# TOP SIDE VIEW

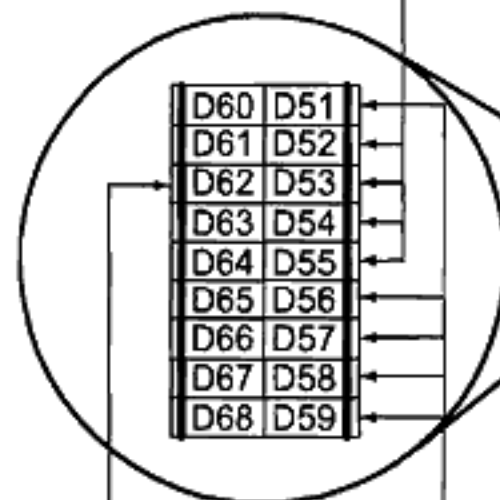
Remove D52–D55 for  
RX freq expansion

Remove D62 for  
5MHz band expansion

Add D51 and remove  
D56–D59 for TX freq  
expansion
